**DA NO:** DA-2023/46  
**ADDRESS:** 117 NEERIM ROAD, CASTLE COVE NSW 2069.  
**PROPOSAL:** ALTERATIONS AND FIRST FLOOR ADDITION TO EXISTING DWELLING, DEMOLITION OF HARDSTAND AREA, NEW DRIVEWAY ACCESS WITH TURNING BAY AND ASSOCIATED WORKS.  
**RECOMMENDATION:** APPROVAL  
**ATTACHMENTS:**

**RESPONSIBLE OFFICER:** RITU SHANKAR - TEAM LEADER  
**AUTHOR:** ADIBA KASHFI – SENIOR DEVELOPMENT ASSESSMENT OFFICER  
**REPORT DATE:** 16 APRIL 2024  
**MEETING DATE FOR ED** ELECTRONIC DETERMINATION

Figure 1 Section

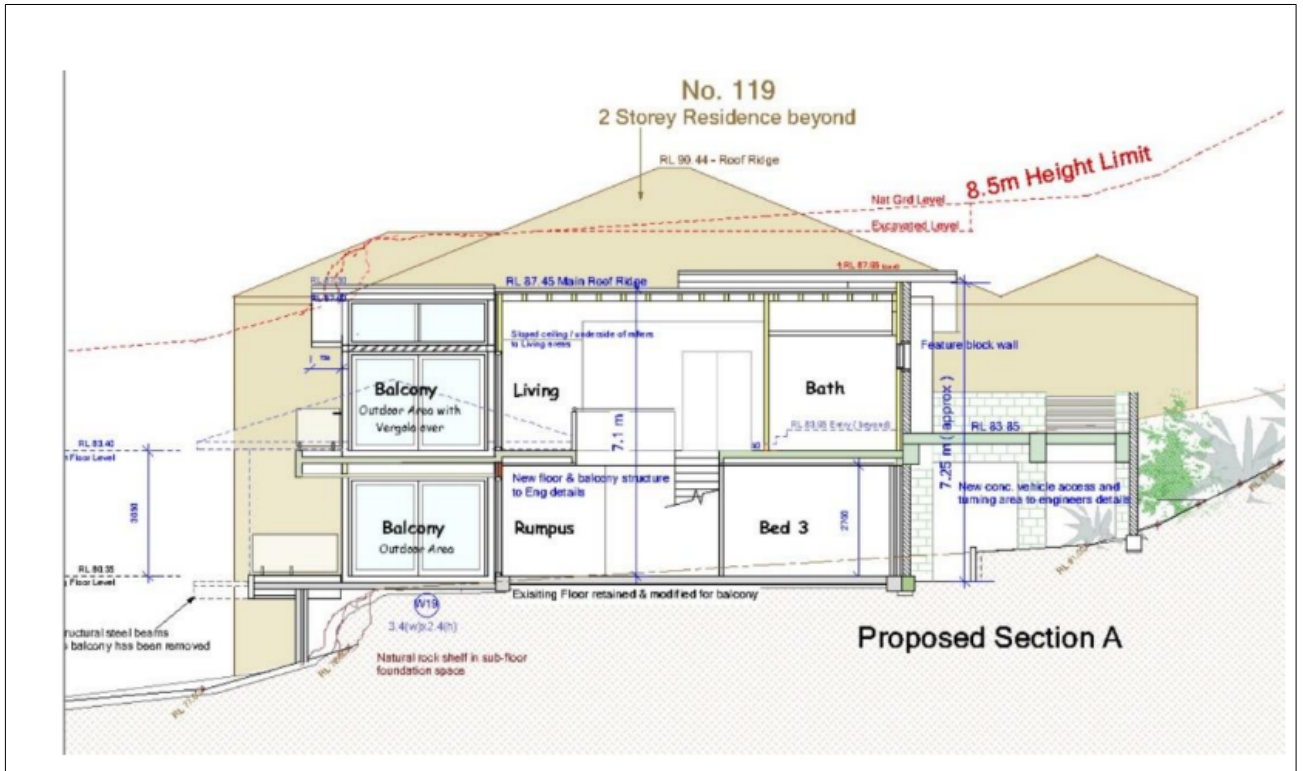
The proposed height of building is 10m which exceeds the permitted maximum height by 1.5m, being a variation of 17.6%.

The existing dwelling sits on a natural rock shelf. The area of non-compliance is a small section of the proposed northern roof ridge. This is due to a significant 'drop away' of the rock shelf the existing dwelling is built upon. Stepping habitable floor space down the slope is considered to be unreasonable in the circumstances.

It is accepted that the objectives of the standard are achieved despite the non-compliance, and that the development is consistent with the existing character and context of the street.

On this basis, it is considered the applicant has adequately demonstrated that compliance with the development standard is unnecessary in the circumstances.

Figure 8 Envelope Breach

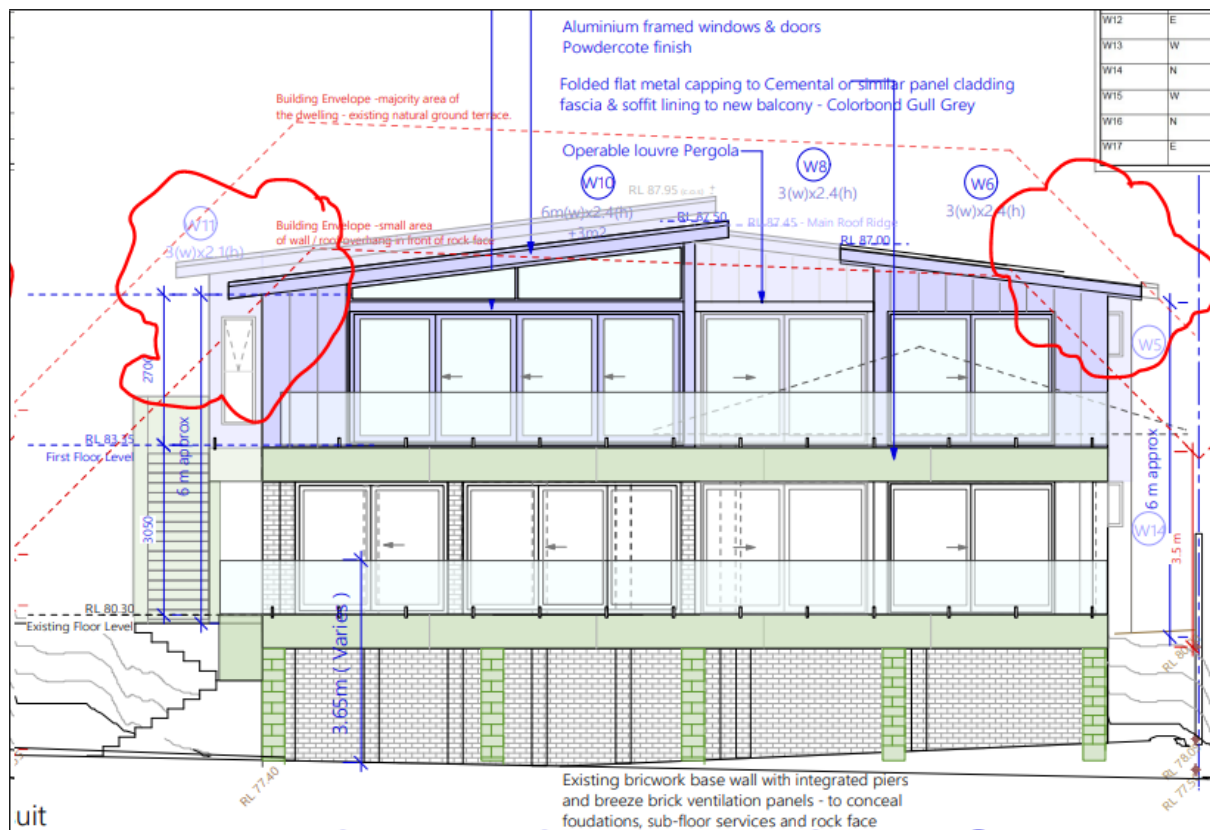
As shown below, the proposal will breach the building envelope control on the northeast and northwest elevation due to the topography and proposed contemporary design.

As shown on the figures above, the encroachment exists on the northwest and northeast elevation. The development will not result in any unreasonable amenity issues for neighbouring dwellings and remains consistent with the objectives of the control, despite the variation. The minor non-compliance does not itself create unreasonable bulk and scale and is considered acceptable.

Figure 9 view retention diagram – 119 Neerim Road, Castle Cove

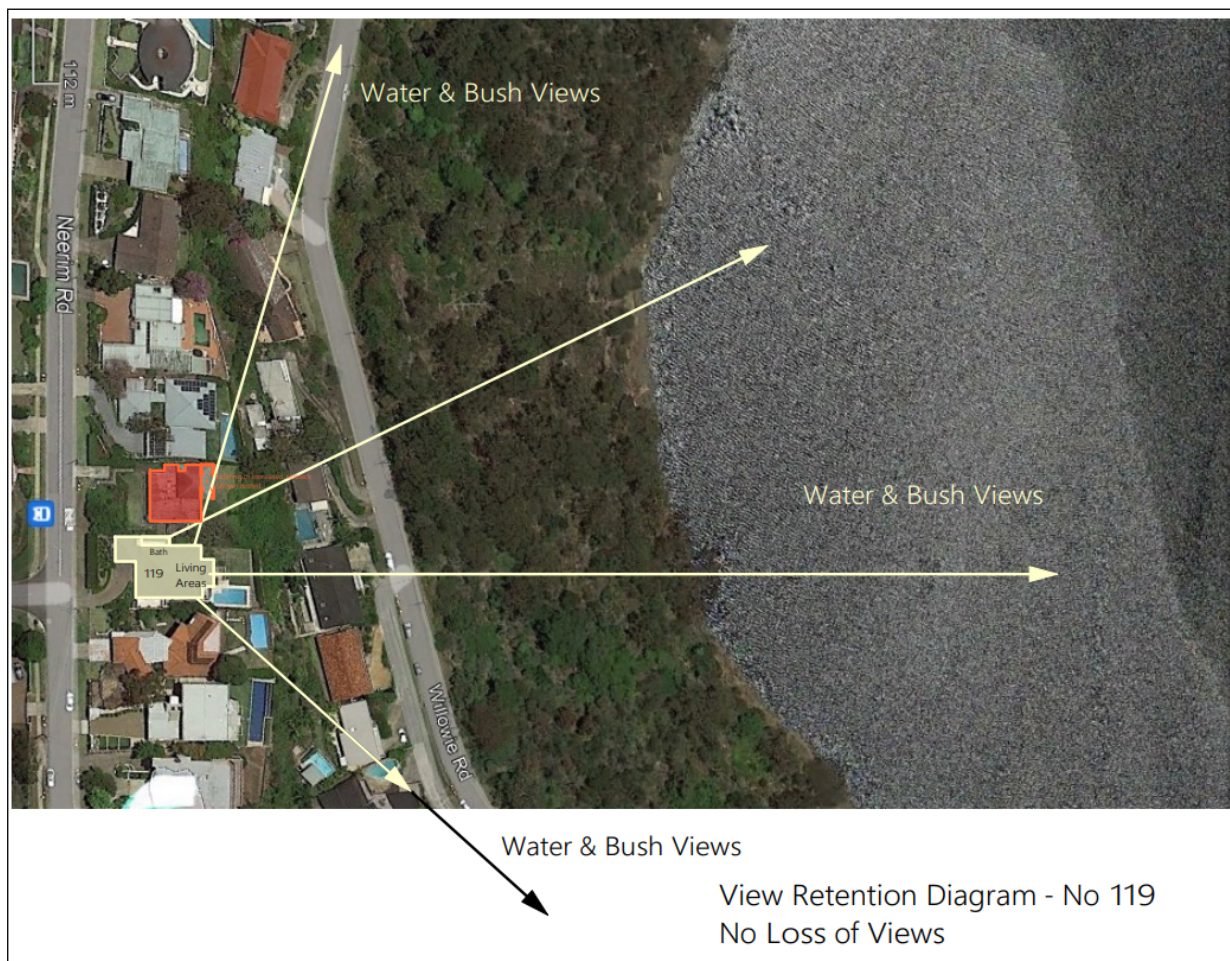
Assessment: No.117 and 119 Neerim road currently have views of Middle Harbour and bush reserve. The existing views are retained and unimpeded by the proposal. The proposed dwelling does not project beyond the existing rear building line established by its neighbours. No.115 Neerim road has no windows on the boundary facing wall at eye level. Only clerestory windows proposal cuts rear building line back behind neighbour's rear walls. Therefore, views cannot be impacted. On the other hand, No. 119 Neerim Road has a balcony toward the side where view will be impacted. However, this balcony only be accessed via the ensuite. Views from Living room and other areas of the house will be maintained. See below figures showing view retention diagrams for No. 115 and 119 Castle Cove.

Figure 13: Potential view loss from Master Bathroom's Balcony

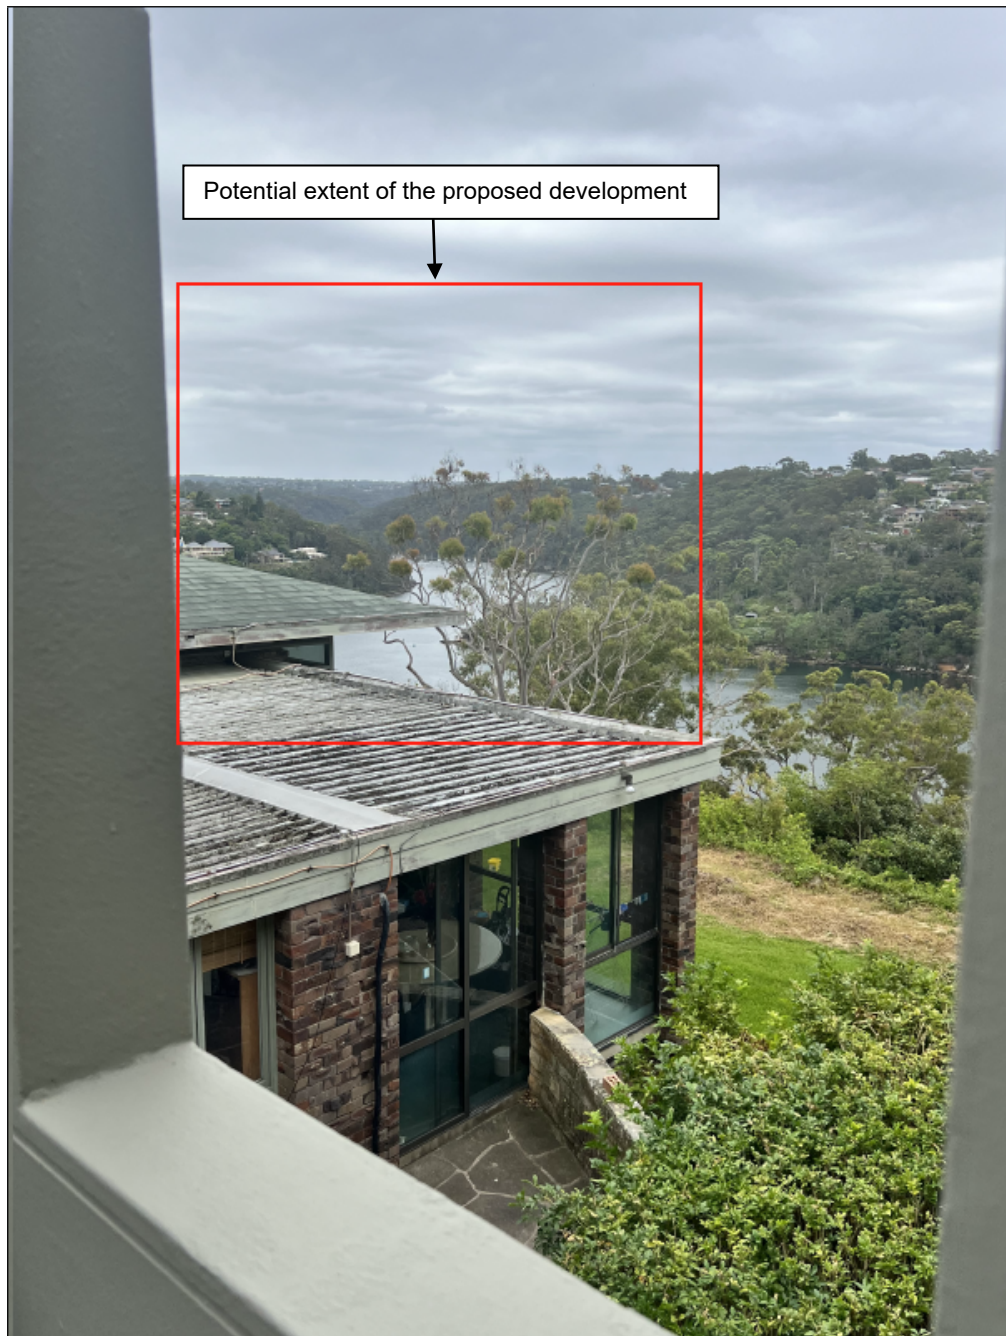
Assessment: As mentioned above, views from living areas and private open space are maintained for both the neighbouring properties. The only view impeded is from the side balcony of 119 Neerim Road, which only can be accessed via the ensuite. The view loss is minor in nature, qualitatively negligible as views from all other areas are being retained.

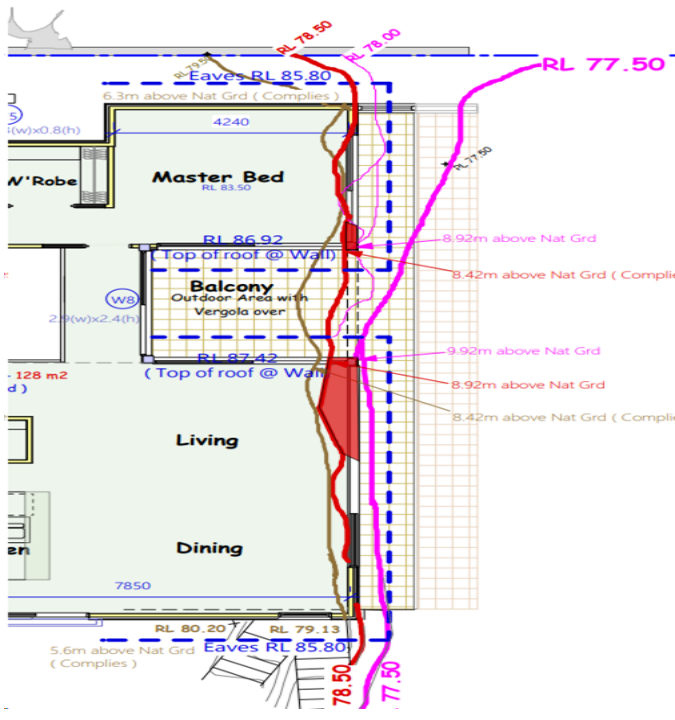
Assessment: Views from living areas and private open space are maintained for both the neighbouring properties. The only view which will be obstructed is from the side balcony of 119 Neerim Road and can only be accessed via the ensuite. The view loss is due to the proposed addition of the first-floor level. Although, there is a height breach proposed, the view loss is not result of this height breach as the it is very minor (see Figure 2). Therefore, the view loss is not due to the height breach but rather is a result of an existing condition. All other views from the property will be retained.
